# Access Compliance Report

## Public Rights-of-Way

Intersection ID: 48493	Main Street: NEWTONMORE_DR	Cross Street: BEREWICK_COMMONS_PY	Location: SW
ADA ID: 3C5812EB1122	Ramp Type: Perp	Initial Pass/Fail: Fail	Overall Compliance: No
Severity Score: 22.5			
Codes/Mitigation Info/Possible Solution		Field Measurements/Component Compliance

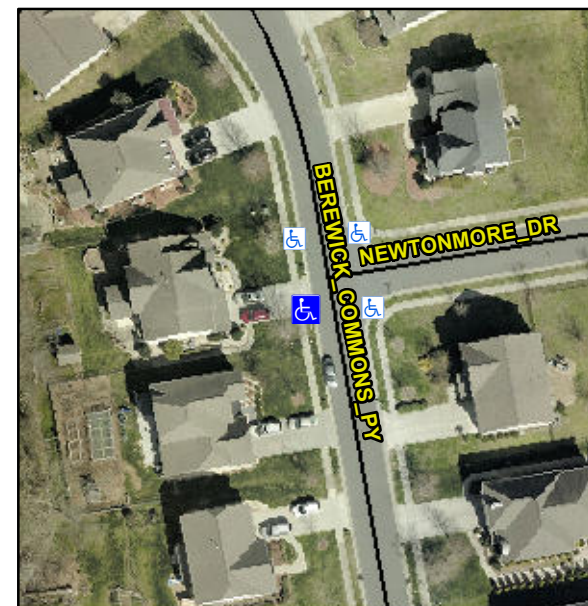
**R304.5.1, R304.2.2, R304.5.3**

Compliance	Description	Data	Compliance	Description	Data
N/A	Ramp Length (in)	48.0	No	Ramp Slope (%)	9.2
No	Ramp Width (in)	47.5	No	Ramp XSlope (%)	2.8
N/A	Flare Type LT	N/A	N/A	Flare Type RT	N/A
N/A	Flare Slope LT (%)	N/A	N/A	Flare Slope RT (%)	N/A
N/A	Flare Traversable LT?	N/A	N/A	Flare Traversable RT?	N/A
N/A	Landing Length (in)	N/A	N/A	DWS Provided?	N/A
N/A	Landing Width (in)	N/A	N/A	DWS Contrast?	N/A
N/A	Landing Slope (%)	N/A	N/A	DWS Length (in)	N/A
N/A	Landing X Slope (%)	N/A	N/A	DWS Full Width?	N/A
N/A	Landing Curb? (Y/N)	N/A	N/A	DWS Offset (in)	N/A
N/A	Shared Landing?	N/A			
N/A	Gutter Ponding?	N/A	N/A	Gutter Slope (%)	N/A
N/A	Gutter Lip Ht (in)	N/A	N/A	Gutter X Slope (%)	N/A
N/A	Painted X Walk1?	No	N/A	Painted X Walk2?	N/A
	X Walk 1 Direction	To E		X Walk 2 Direction	N/A
N/A	X Walk 1 Width (in)	N/A	N/A	X Walk 2 Width (in)	N/A
	X Walk 1 Slope (%)	2.1		X Walk 2 Slope (%)	N/A
	X Walk 1 X Slope (%)	2.2		X Walk 2 X Slope (%)	N/A

**Remove & Replace Entire Ramp.**
